DOCUMENT 00912

ADDENDUM NUMBER 2

Issued: June 8, 2006

Tertiary Treatment Plant Upgrade

DRAWING NUMBER C-6B

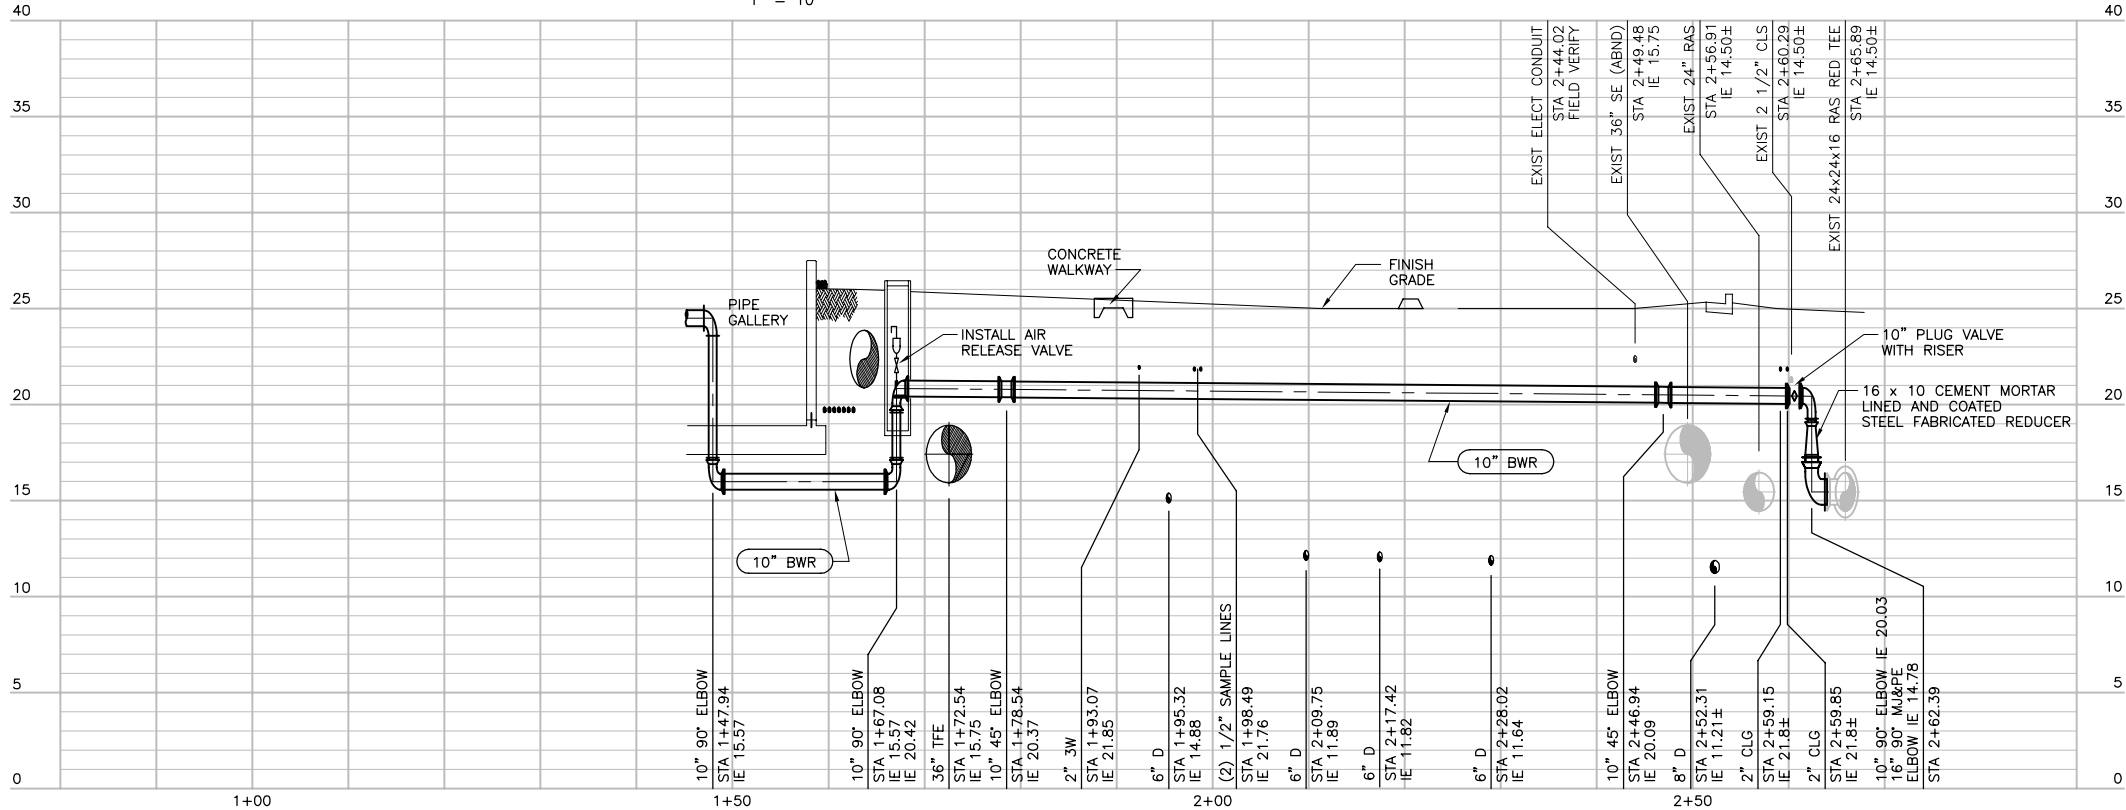
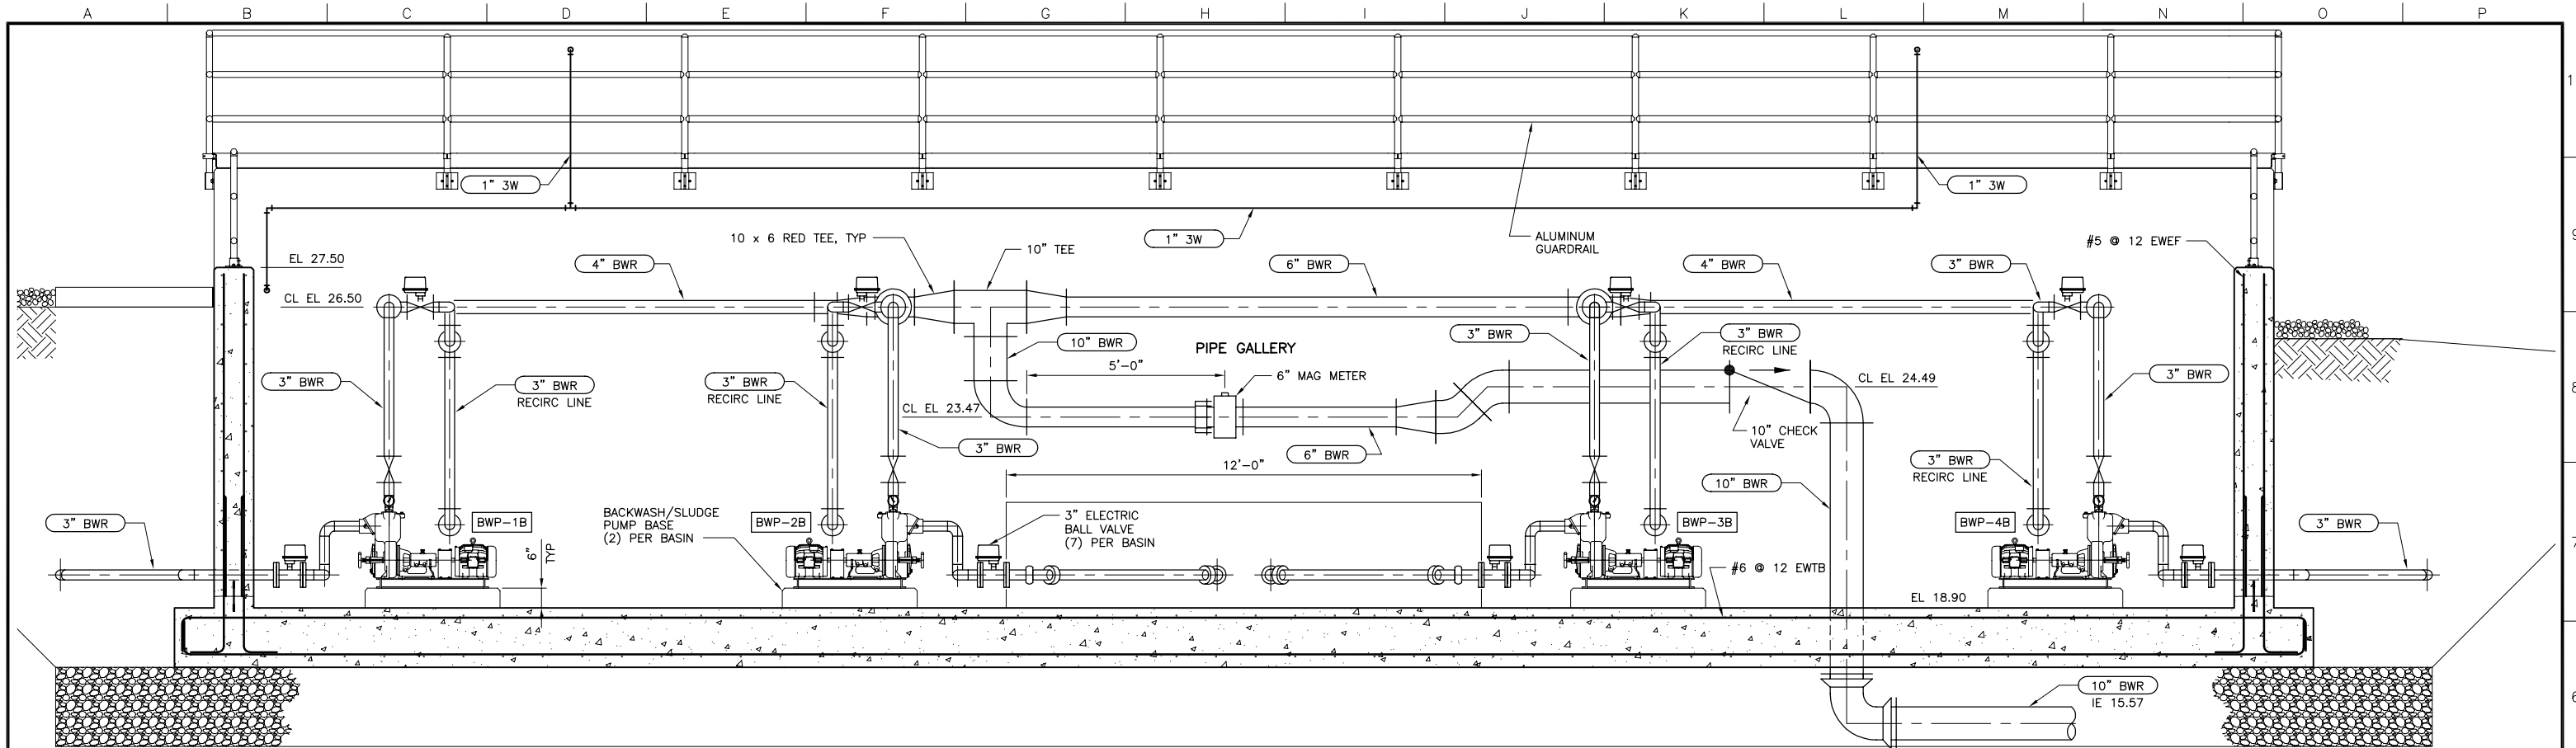
- E. Drawing Number C-6B (Sheet Number 17B):
 1. Replace Drawing in its entirety with reissued Drawing C-6B, attached
- F. Drawing Number C-7B (Sheet Number 18B):

3", 6" BWR and MAG flow

The situation that all backwash pumps running at one time can happen and backwash discharge piping shall be design to accommodate all pumps running at one time. Please revise backwash discharge pipes as follows:

4" BWR for 2 pumps,
6" BWR for 4 pumps,
10" BWR for 8 pumps.

ALTERNATIVE "B" 10" BACKWASH RETURN PROFILE

DRAWING NUMBER **SP-8B** SHEET NO. **30B** OF **64**

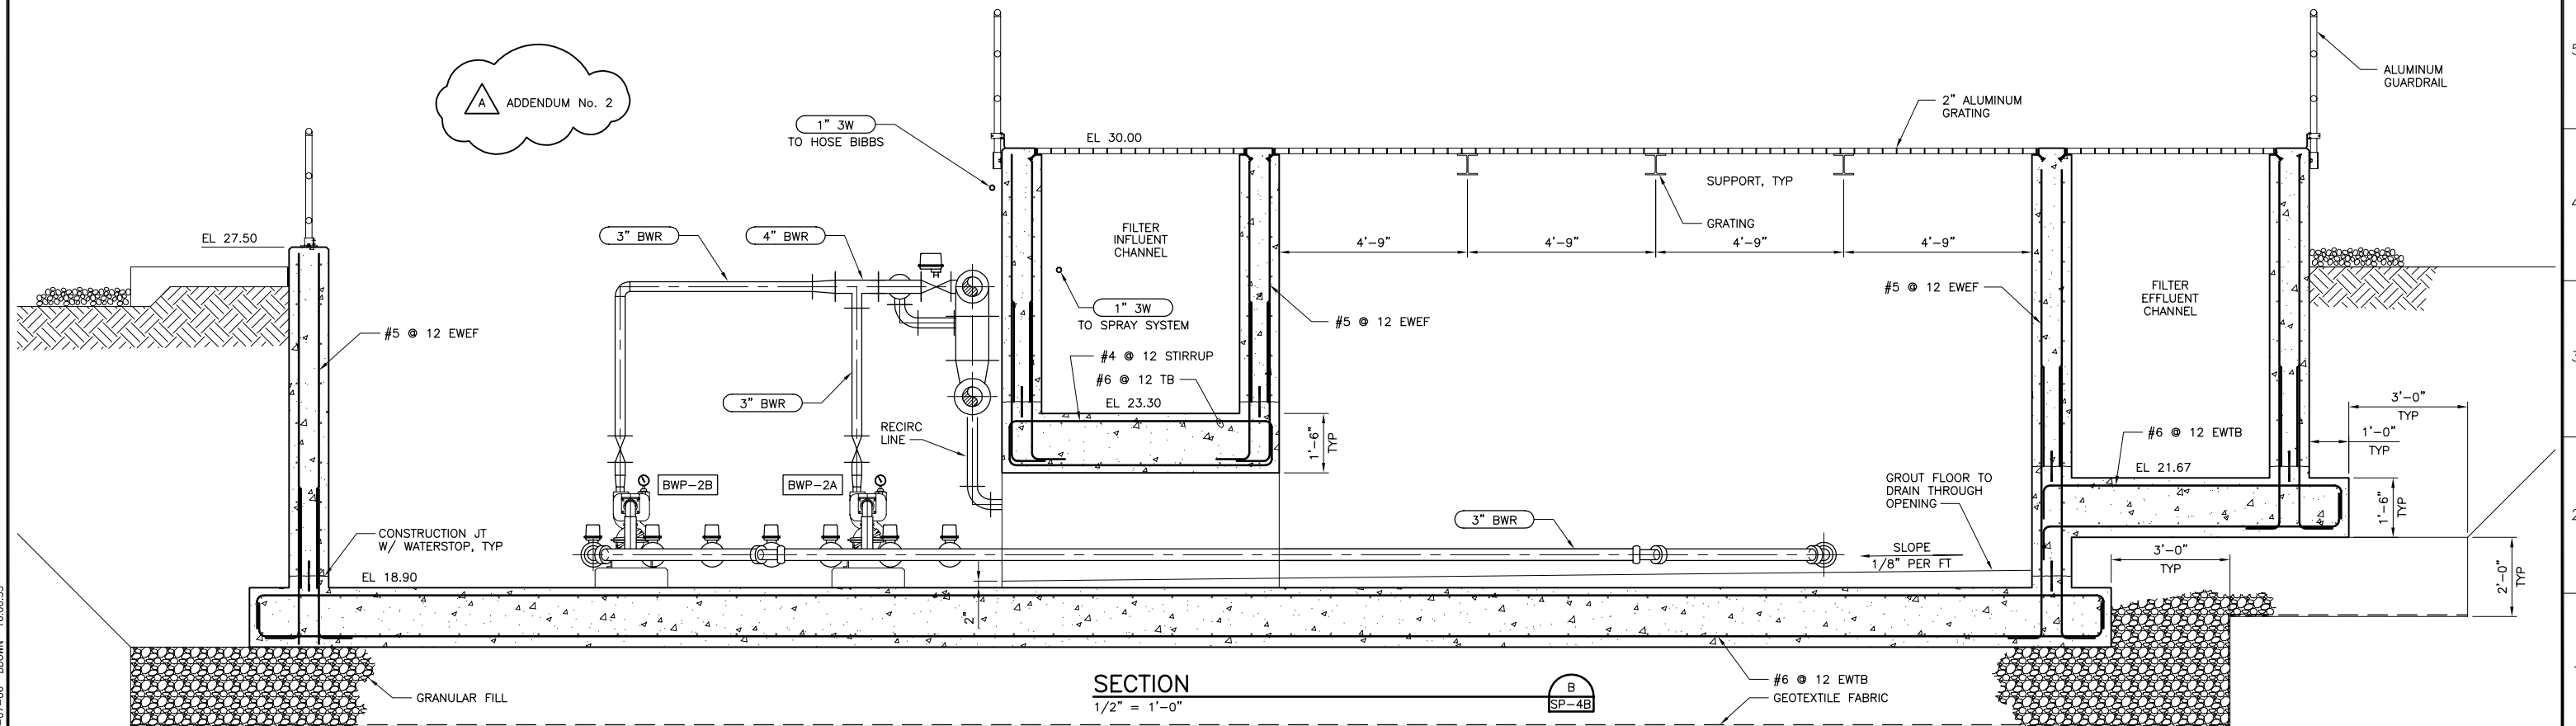
1. Replace Drawing in its entirety with reissued Drawing SP-8B, attached

Due to the positive shut off of the backwash ball valves and the internal check valve of self priming backwash pumps, the external check valves for backwash discharge pipes would be the second check valve in the backwash system (internal check valve inside

the pump and another check valve external). Please delete the external check valves or please confirm if it is required.

Please confirm the isolation valves in the backwash discharge pipes in drawing 29B, 30B are gate valves as specified in section 11210-4.F.1.

There are two isolation valves in the same backwash discharge pipe (pump BWP-2B, section B, drawing #30B of 64). Please delete one of the two isolation valves (redundant).
